Errata: CS43L42 Rev. DCS43L42 Low Voltage, Stereo DAC with Headphone Amp

All references to the CS43L42 mentioned below shall be taken to refer to revision D of the CS43L42 product. The hardware revision code can be found in the 10-character field printed below the part number on each chip. The letter which appears as the fifth character from the right is the revision code (e.g. ZNACSD9926 is a Revision D part).

Figure 1. Pop Guard Fix

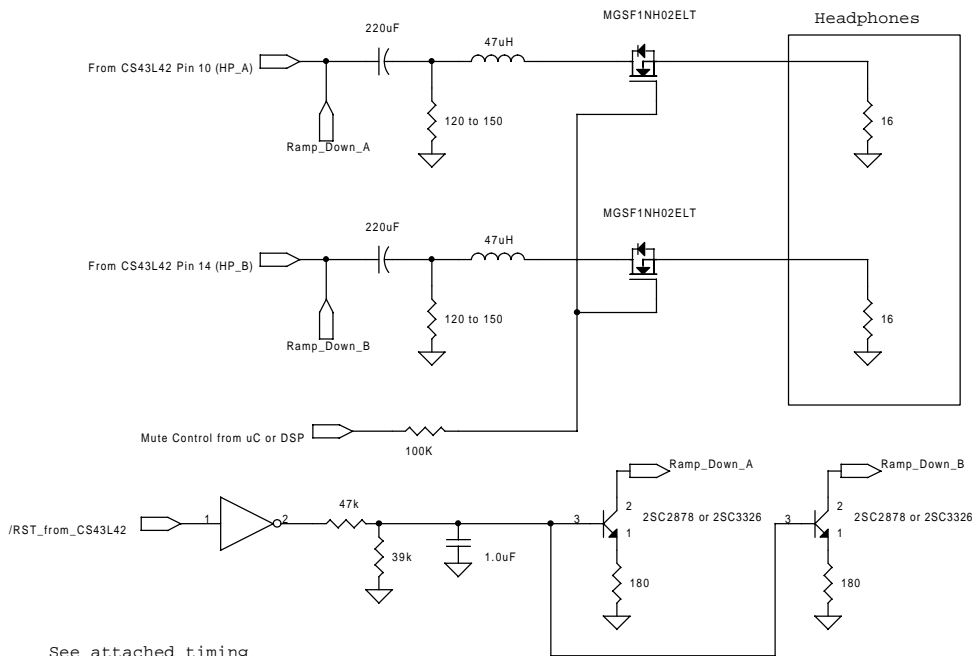
- The PopGuard[®] Transient Control does not function properly and will produce audible artifacts on the headphone and line outputs during power-up. A hardware fix is available for this issue. Please see Figures 1 and 2 for the headphone output fix. For the line outputs, please use the optional mute circuit shown in the CDB43L42 schematic to mask this problem.

- The PopGuard[®] Transient Control power-down ramp requires 5 seconds to prevent audible artifacts on the headphone outputs at the next power-up. A hardware fix is available for this issue, see Figures 1 and 2 for details. This fix will reduce the ramp down time to approximately 300 milliseconds.

The Motorola MOSFETs shown have been tested to work properly, however, an equivalent device may be used.

2SC2878 is in TO-92 package
2SC3326 is in SOT-23 package

The Toshiba transistors or equivalent will work best here. The device used must have a very low R_{on} (3 ohms or less).

Figure 2. Timing for Pop Guard Fix

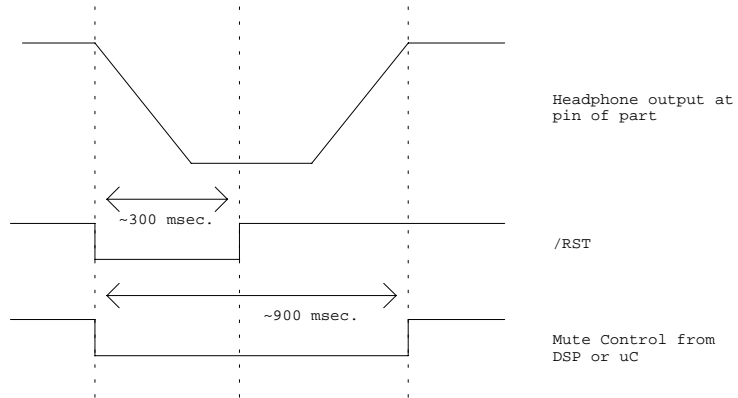
See attached timing diagram for /RST and the Mute control. Customer will need to generate the mute control from their DSP or micro-controller.
